Warren County Regional Planning Commission

Subject: RPC Recommendation for Clearcreek Heights PUD Stage 1 Rezoning

MEETING DATE: March 27, 2025
TO: WCRPC Executive Committee
FROM: Ryan Cook, Senior Planner
SUBJECT: Clearcreek Heights PUD Stage 1 Rezoning

Typical Public Street Sections – The proposed typical street section is 50' right-of-way with 15' public utility easements shown below.

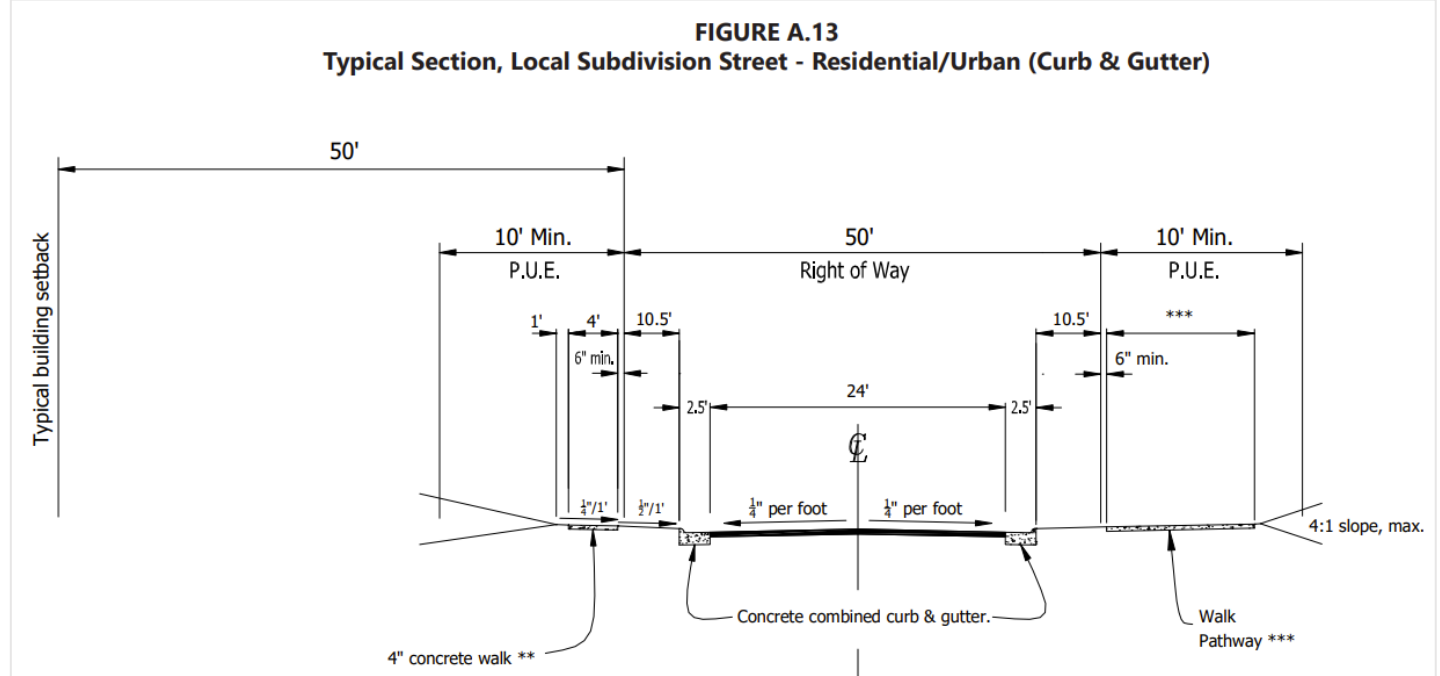
5. Compliance with the requirements of the Warren County Engineer's Office. The Warren County Engineer's Office shall review the proposed street cross-sections and roundabout dimensions at Preliminary Plan.

- a. Central sewer service is required
- b. Central water service is required
- c. Thoroughfare Plan right-of-way along State Route 73 shall be dedicated with the first Final Plat section (Primary Arterial – Rural)
- d. The first Final Plat shall include a stub street connection to Steeplechase Drive.
- e. Streets shall be developed with 15' of public utility easement on both sides.

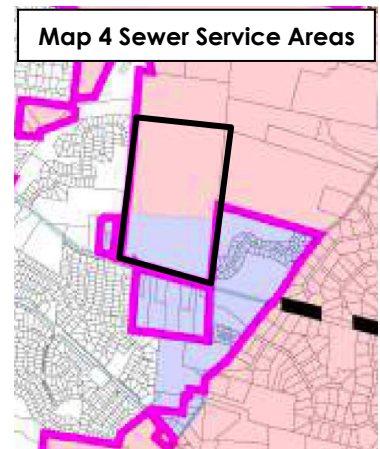
This varies from the Thoroughfare Plan's typical section of 50' right-of-way and 10' public utility easements shown below.
